ADDENDUM NO. 04

Project: **A NEW TRANSPORTATION FACILITY**
Dickinson Independent School District

Project No.: **0806**

BAY ARCHITECTS 18201 GULF FREEWAY P.O. BOX 891209 HOUSTON, TEXAS 77289 281.286.6605	A NEW TRANSPORTATION FACILITY DICKINSON I.S.D.	ADD-4-6 0806 1"=30" 03/31/2010 C2.18
--	--	---

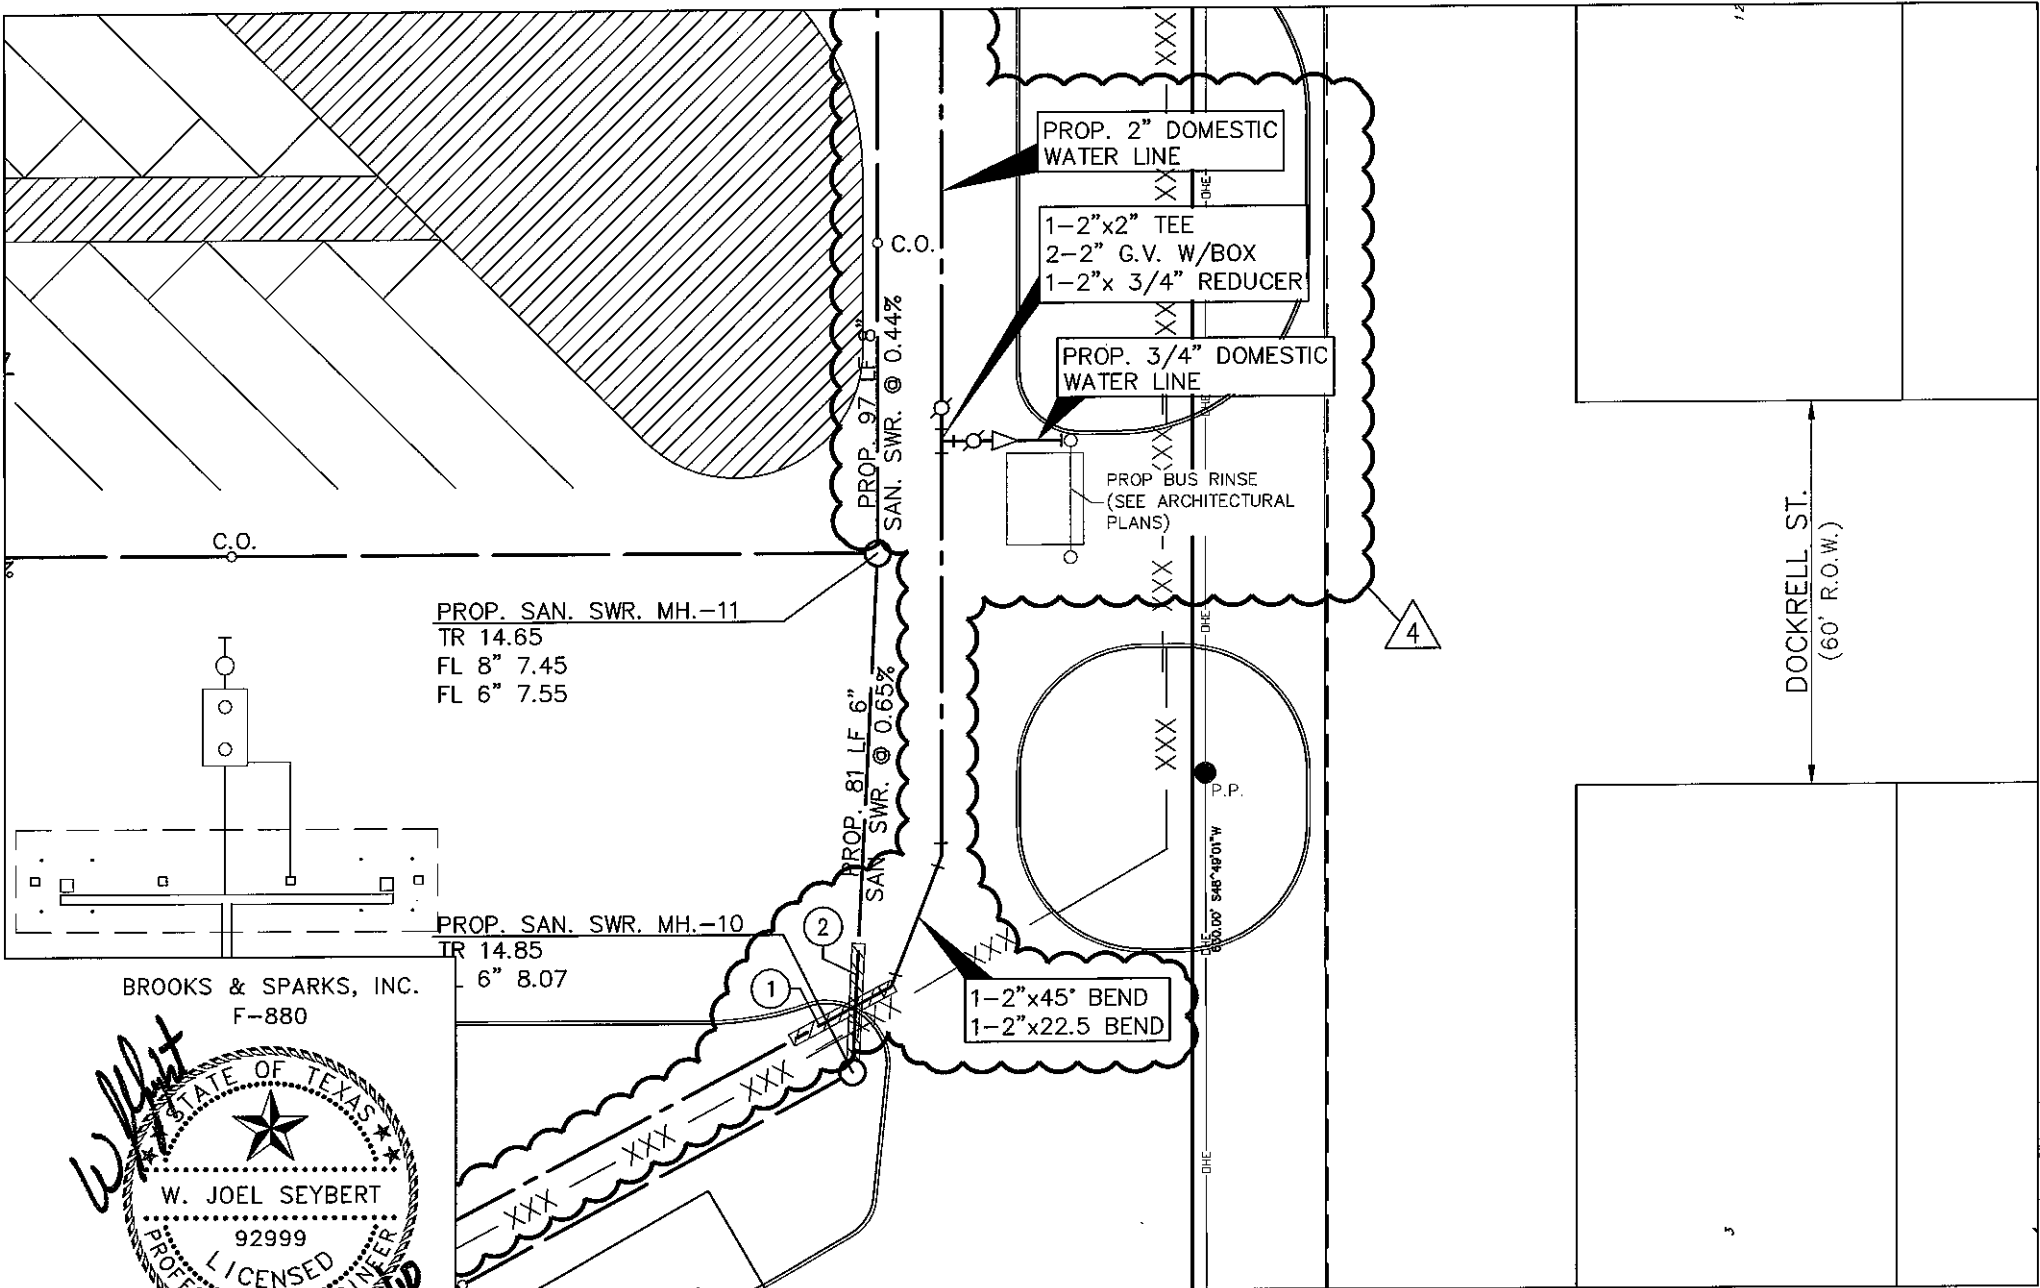
11. Sheet C2.11 Storm Sewer (Sheet 2 of 3): Add proposed oil separator and connect to proposed storm sewer as shown on attached sketch **ADD-4-5**.
12. Sheet C2.18 Water and Sanitary Sewer Plan (Sheet 2 of 3): Add proposed 2" water line to serve bus rinse as shown on attached sketch **ADD-4-6**.

ADD-4-7
0806
1"=30"
03/31/2010
C2.18

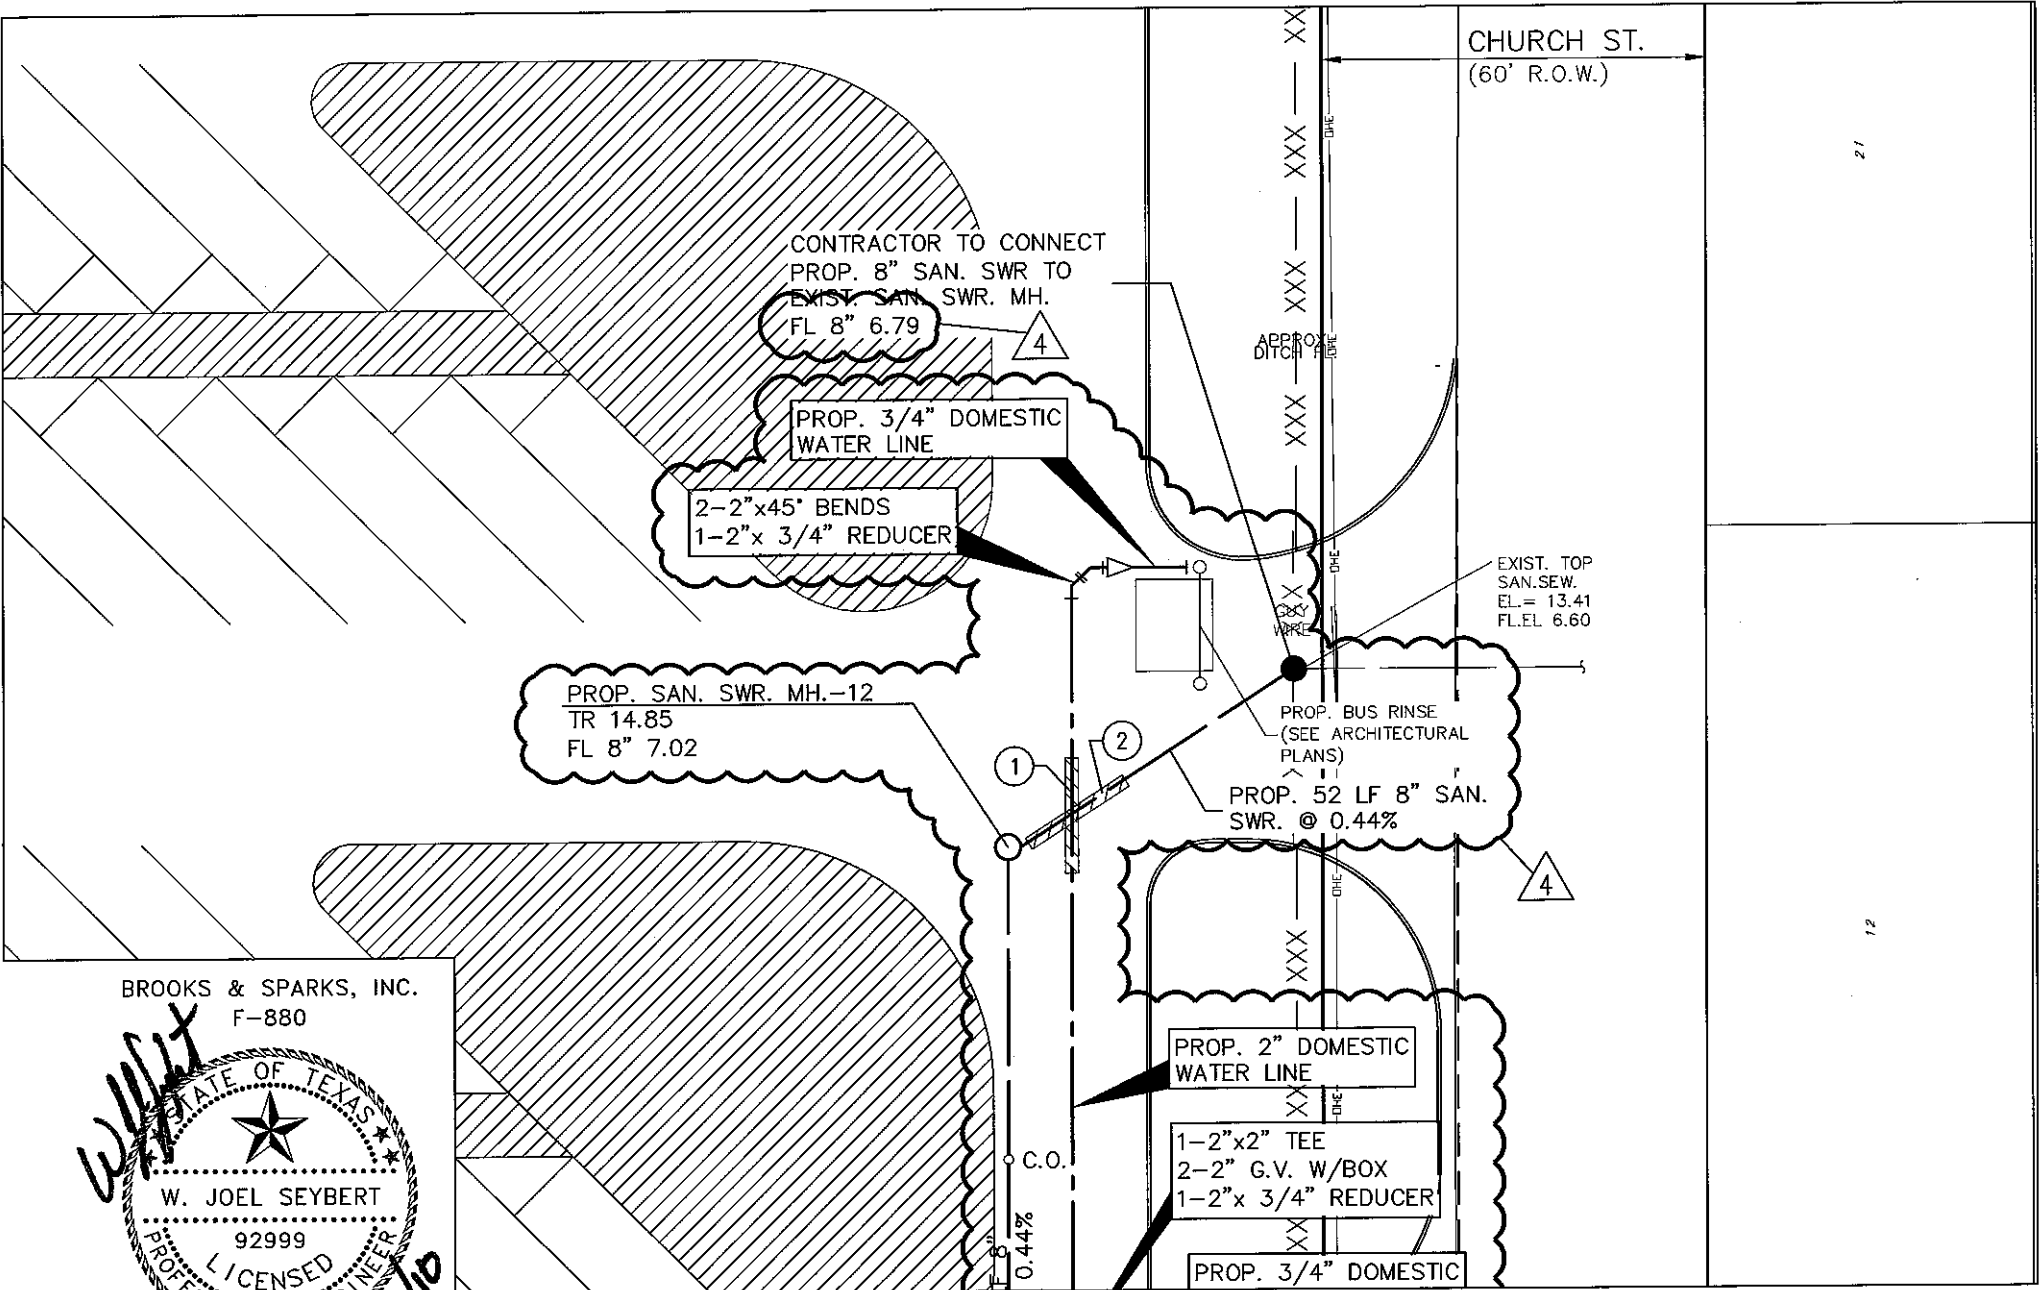
13. Sheet C2.18 Water and Sanitary Sewer Plan (Sheet 2 of 3): Add proposed 2" water line to serve bus rinse as shown on attached sketch **ADD-4-7**.
14. Sheet C2.18 Water and Sanitary Sewer Plan (Sheet 2 of 3): Add proposed 2" water line to serve bus rinse and move proposed sanitary sewer out from under bus rinse as shown on attached sketch **ADD-4-8**.
